MAplication : 10/731,187
Filing Date : 12/09/2003
Inventors : Sivarama K. Kuchibhotla et al.
Title : **ILLUMINATION COMPENSATOR FOR CURVED
SURFACE LITHOGRAPHY**

Date : Friday, October 14, 2005

SECTION D – Remarks:

Fig. 9

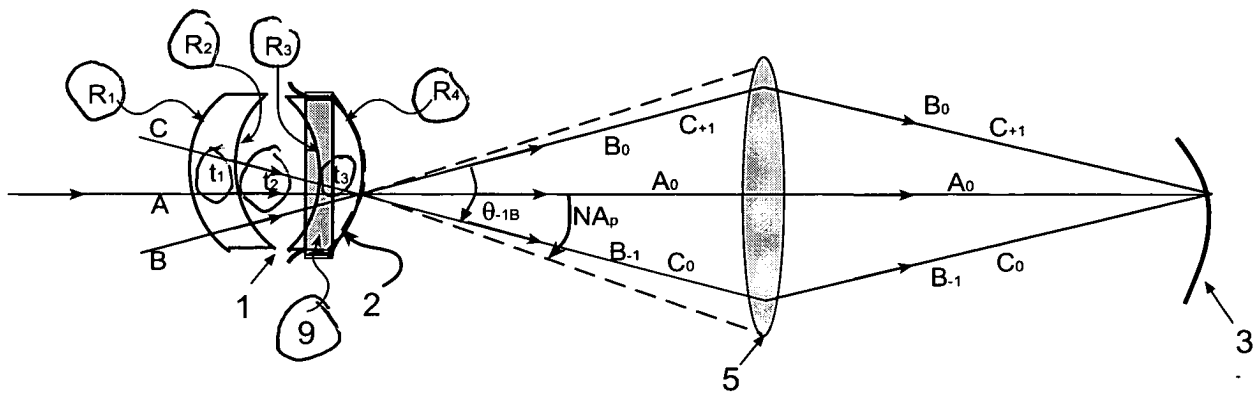
Drawings have been corrected by amendment in a replacement sheet. Acceptance of the corrected drawings is requested. These changes, which are being made pursuant to the Examiner's suggestion to conform existing drawings to existing written description, do not raise any issue of new matter. Designations R_1 , R_2 , R_3 , and R_4 and designations t_1 , t_2 and t_3 are now shown in Figure 9. Locking band 9 is now shown in Figure 9.
